**Report: ISSUES**

**Function: Test, Adjust, & Balance**

## 09-04-23 PENN STATION - BELLEVUE, NE

Project: 09-04-23 PENN STATION - BELLEVUE, NE

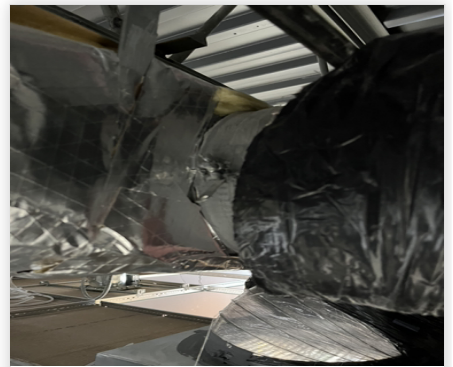
**Issue Name :** DIFFUSER 2-9 plastered shut  
**Description :** Damper on diffuser 2-9 on the GRD is plastered shut and is allowing no airflow through. The damper needs to be free to be locked down at the proper airflow.  
**Created By :** National TAB                      **Assigned To :** National TAB - Jacob Davidson  
**Status :** Open  
**Originated Date :** 09/11/2023 - Jacob Davidson - National TAB
